TB 133

TECHNICAL BULLETIN

Product : Maxilift Hydraulic models – Direct acting

Subject : Fixings on direct acting sling extension

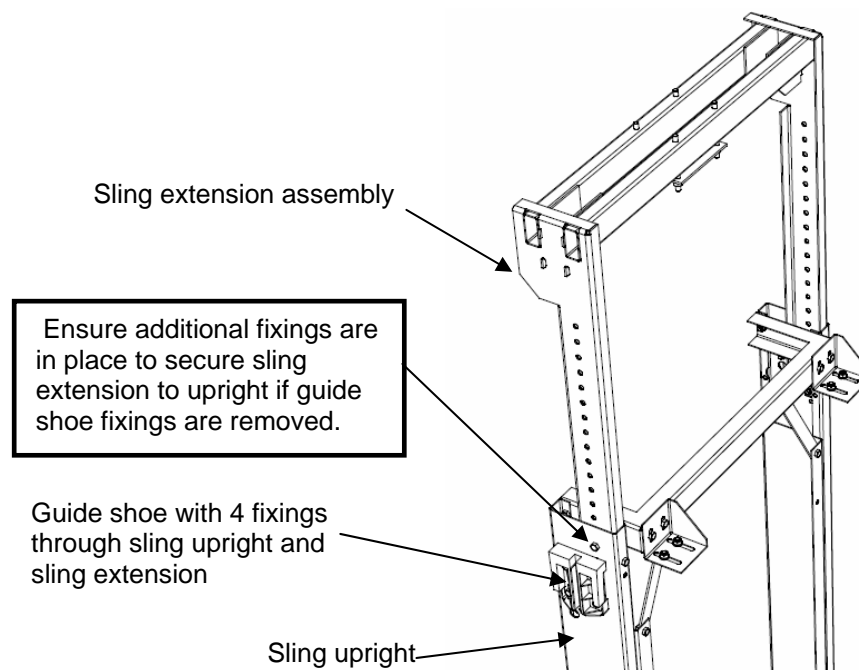
The issue relates to direct acting hydraulic Maxilift models manufactured between May 2001 and August 2006. During this time guide shoes were fitted at the top of the sling and the guide shoe fixings also secured the sling extension assembly to the sling uprights. Removal of the guide shoe fixings can therefore result in the lift becoming detached, causing the lift car to drop if additional fixings have not been used in the additional holes provided, as intended.

It is recommended that site personnel are extra vigilant when removing fixings from direct acting slings. If a guide shoe needs replacing it is important to check that additional fixings have been utilized to secure the sling extension assembly to the sling uprights. Failure to do this can result in the lift becoming detached causing the lift car to drop.

It is therefore also recommended that this work is carried out with the lift positioned on the buffers or pit prop.

A different design has been used since August 2006 incorporating rollers instead of guide shoes which do not utilize the same fixings to secure the sling extension.
